PTS STANDARDS - 100 SERIES DRAWINGS
STANDARDS FOR ROADWAY CONSTRUCTION
APRIL 2022 EDITION – CHANGE NO. 2 – NOVEMBER 2023

PTS – 100 SERIES DRAWINGS

PENNSYLVANIA TURNPIKE COMMISSION
INDEX OF STANDARDS FOR ROADWAY CONSTRUCTION

FILE NAME: PTS-130-1.dwg
DRAWING TYPE: 5A

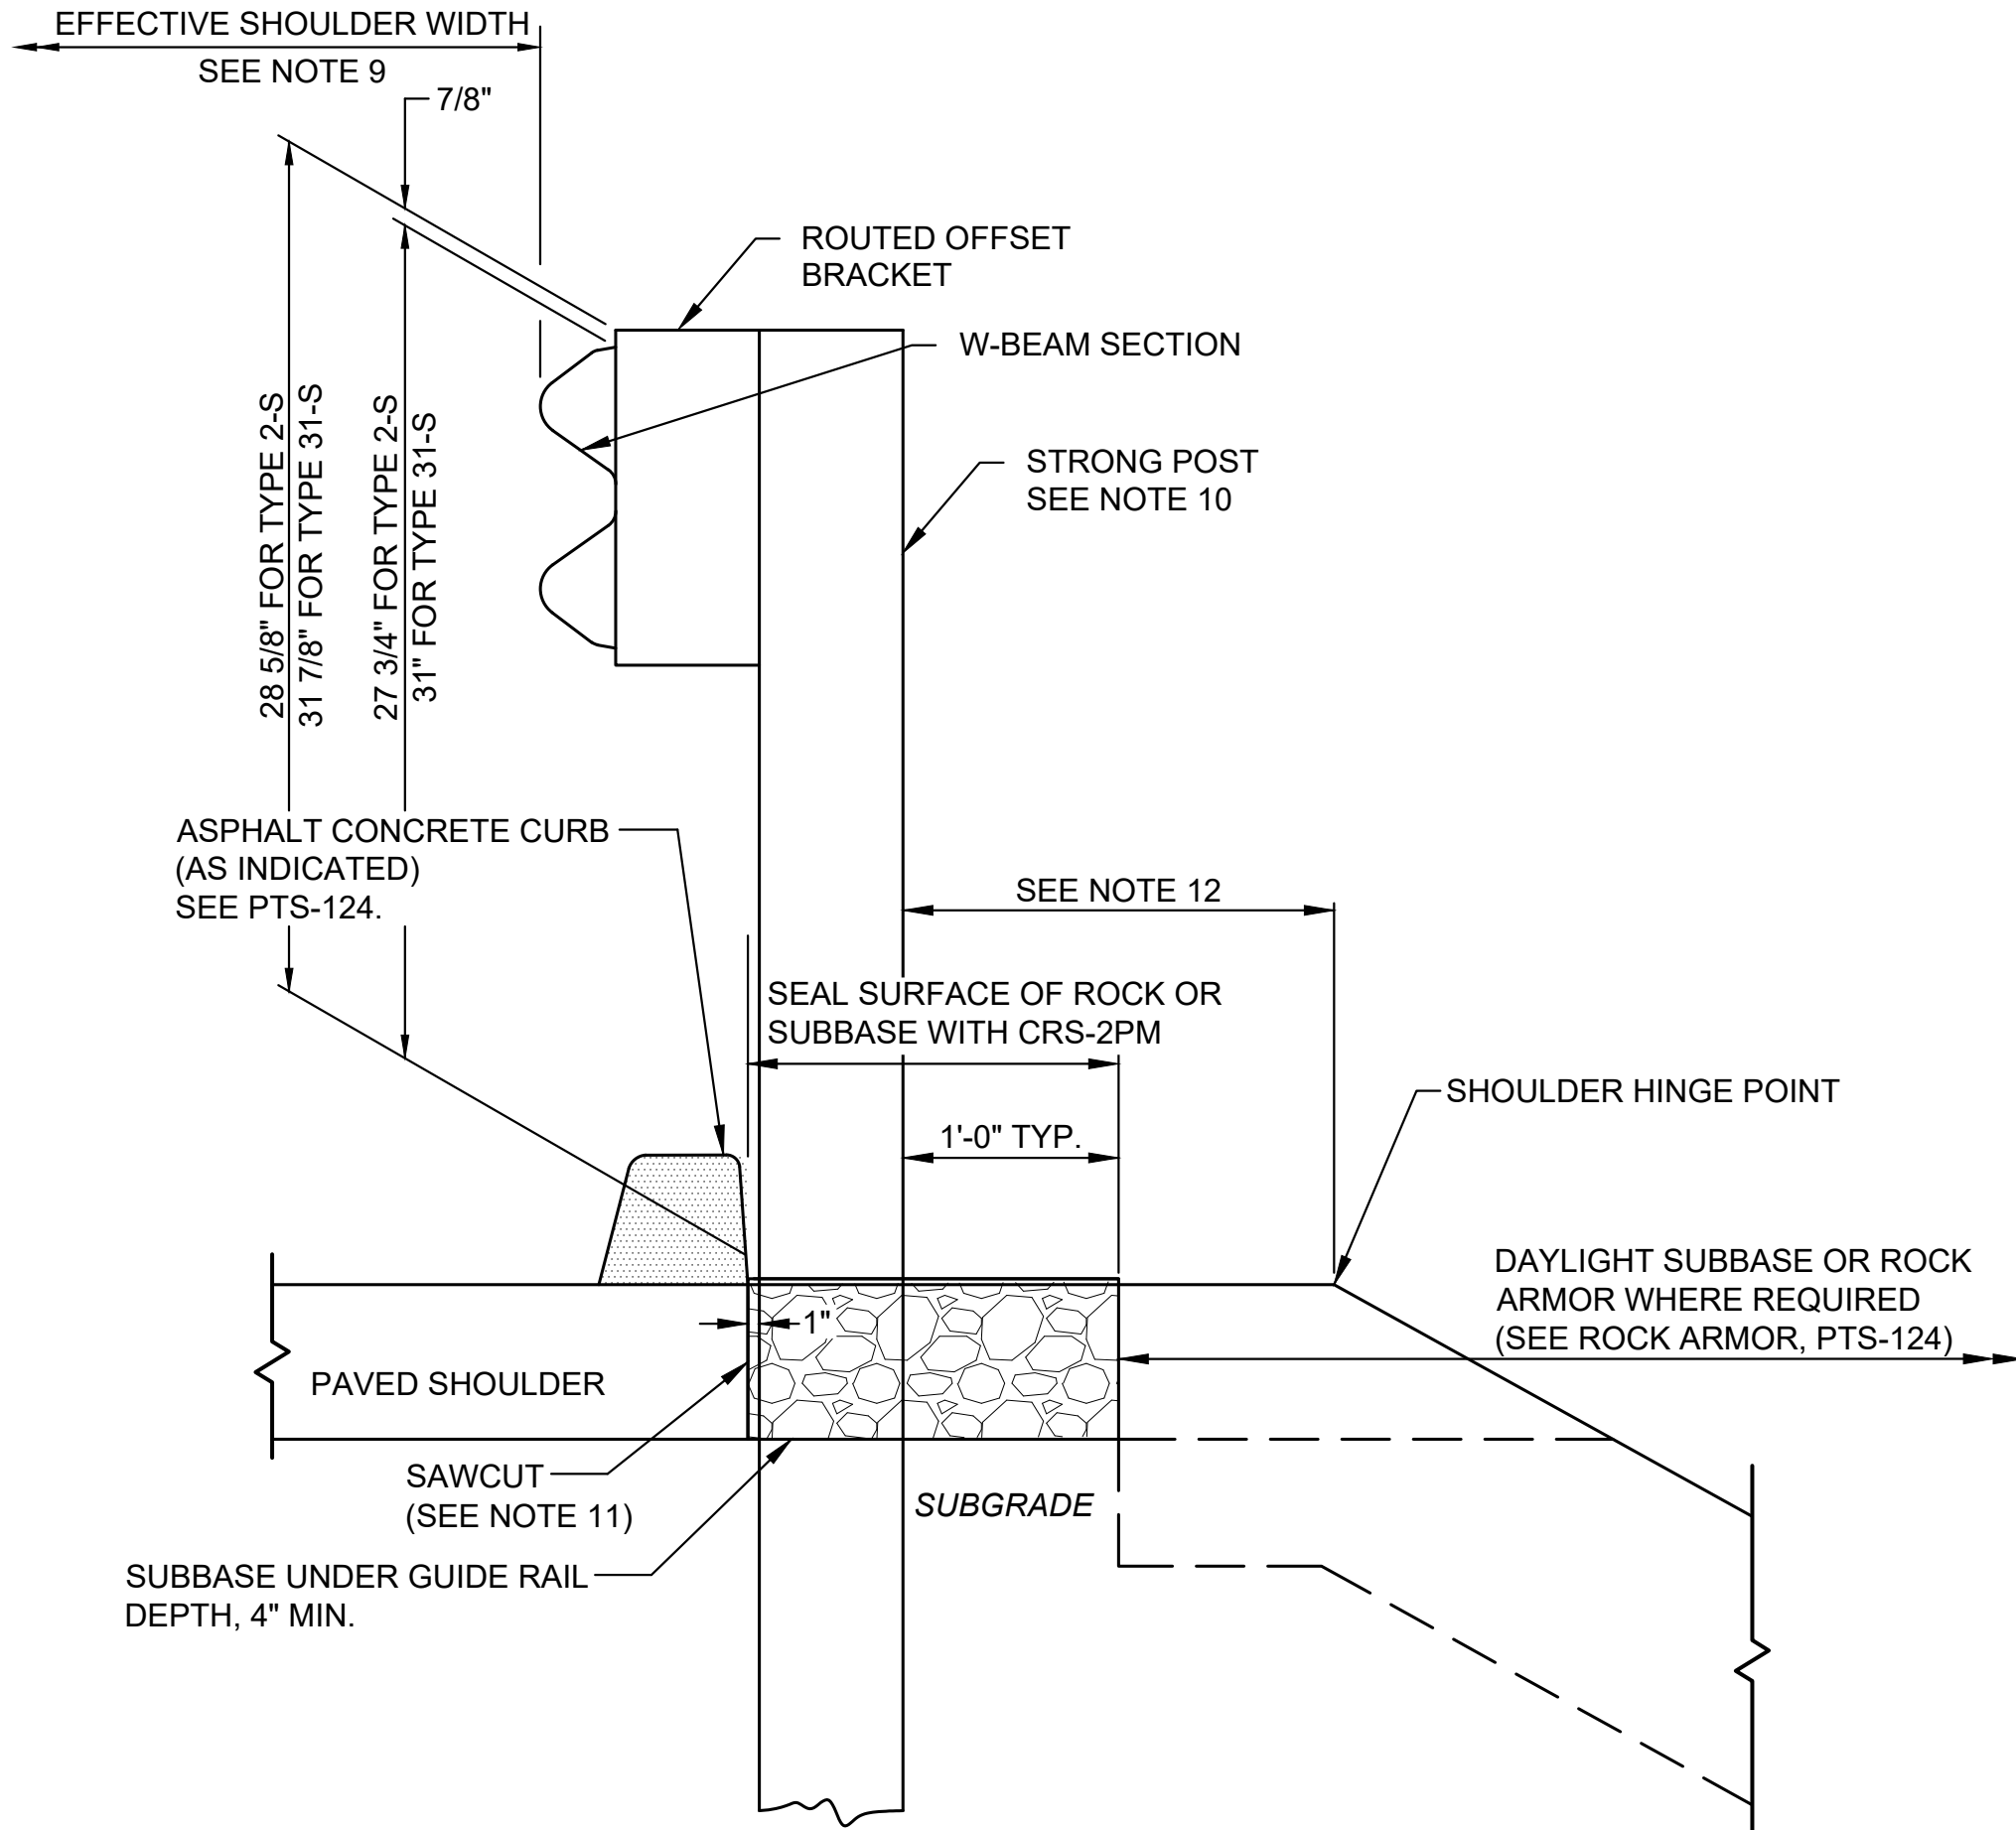
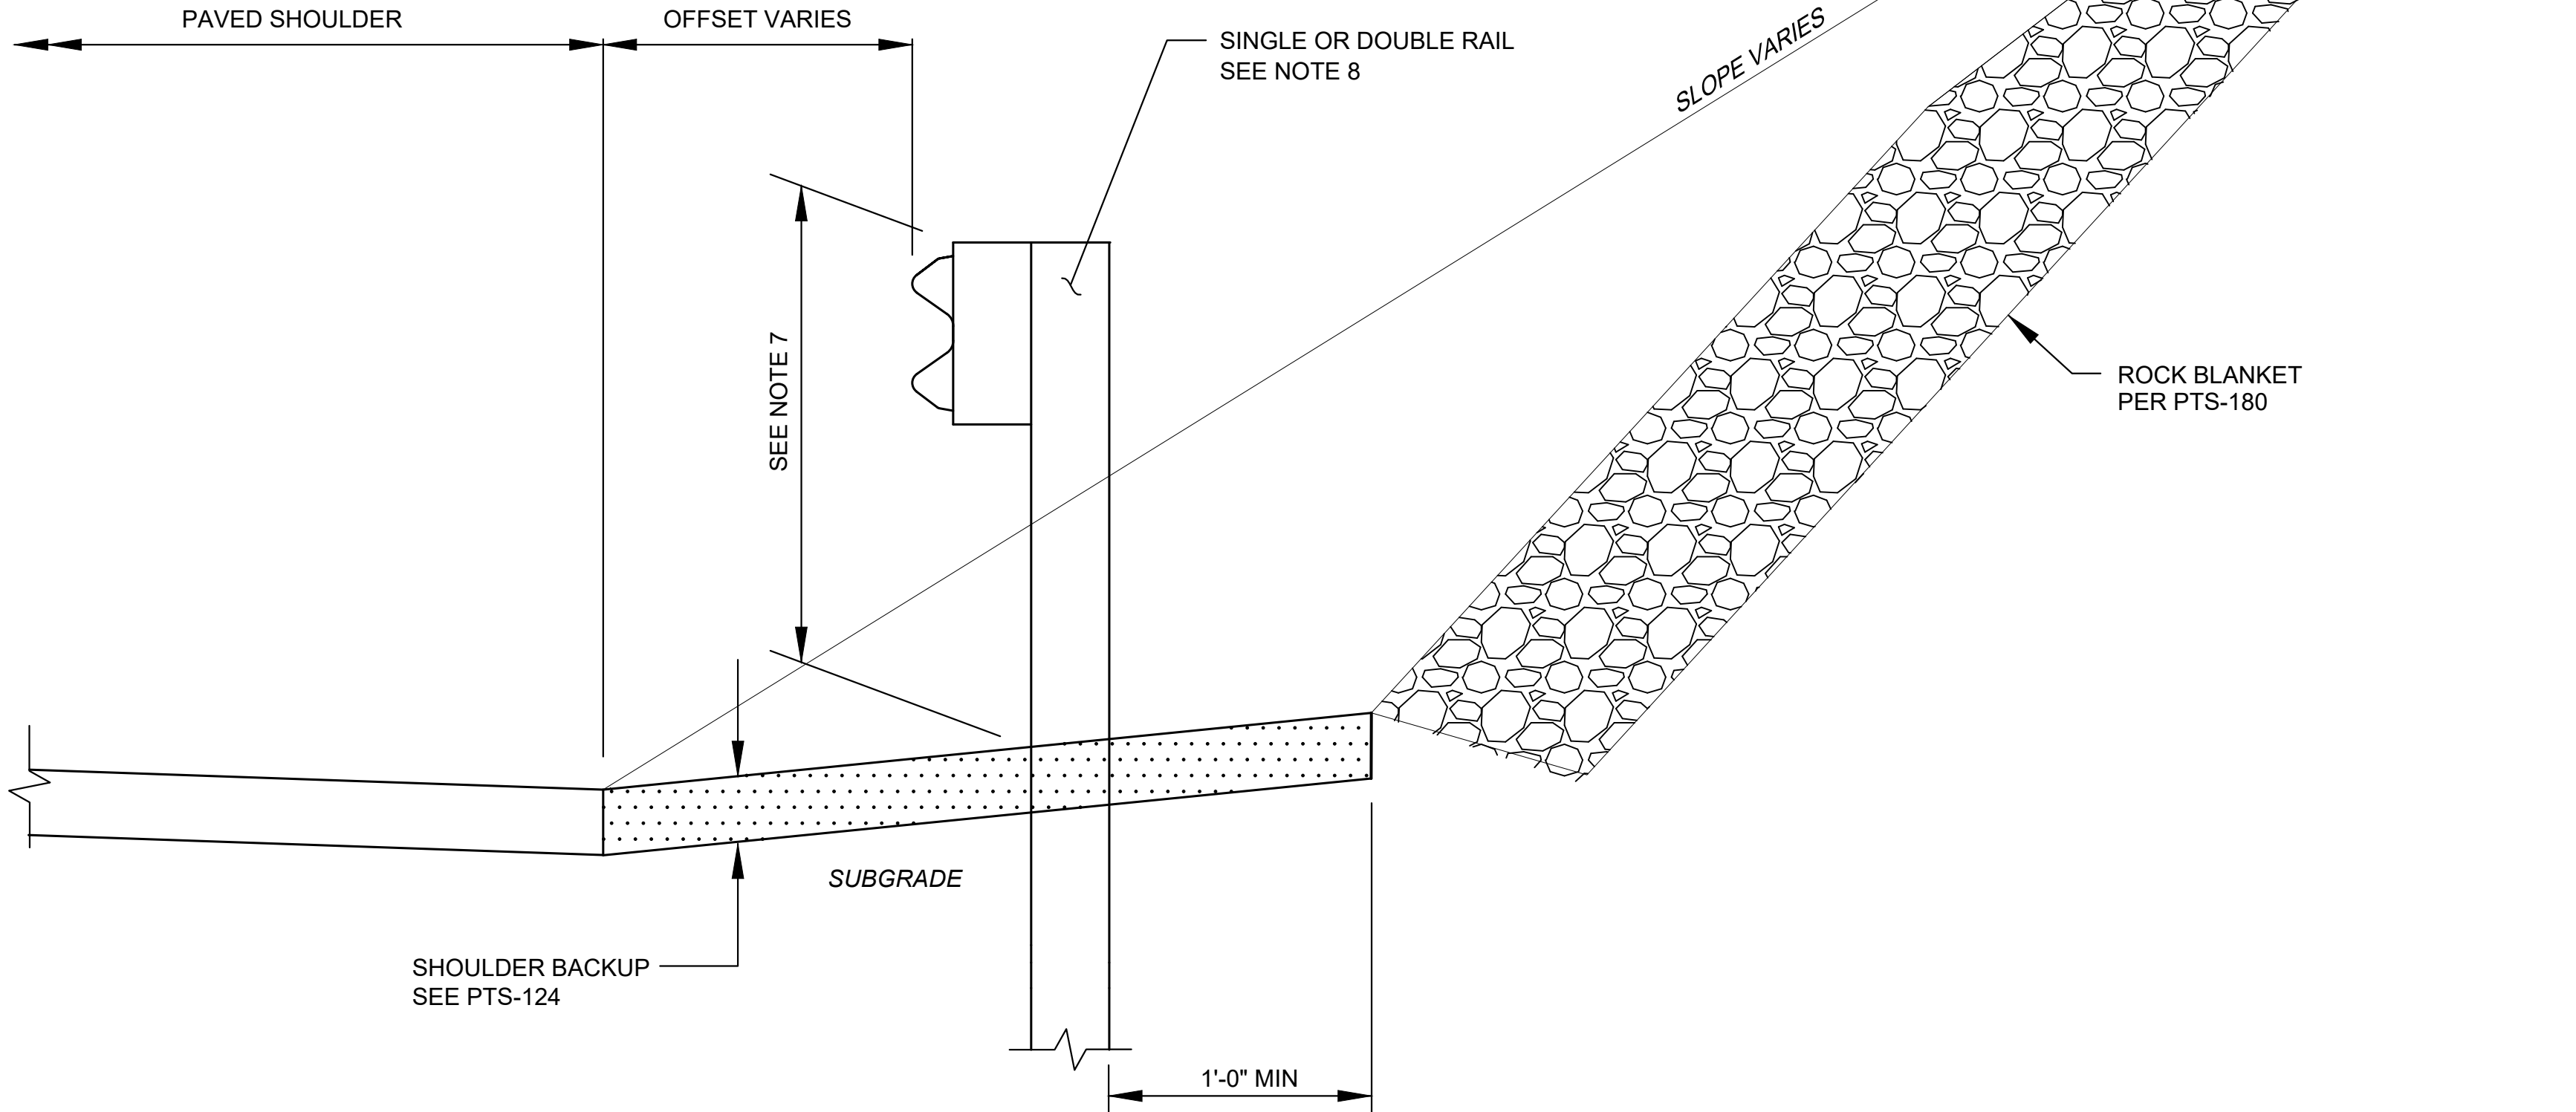
REVISED CALLOUT FOR SUBBASE UNDER GUIDE RAIL TO INDICATE “DEPTH, 4” MIN.”.
EXTENDED THE LIMITS OF THE SHOULDER BACKUP IN THE PLAN AND SECTION VIEW.
ADDED SUBGRADE INDICATION IN BOTH THE SECTION A-A AND B-B VIEWS.
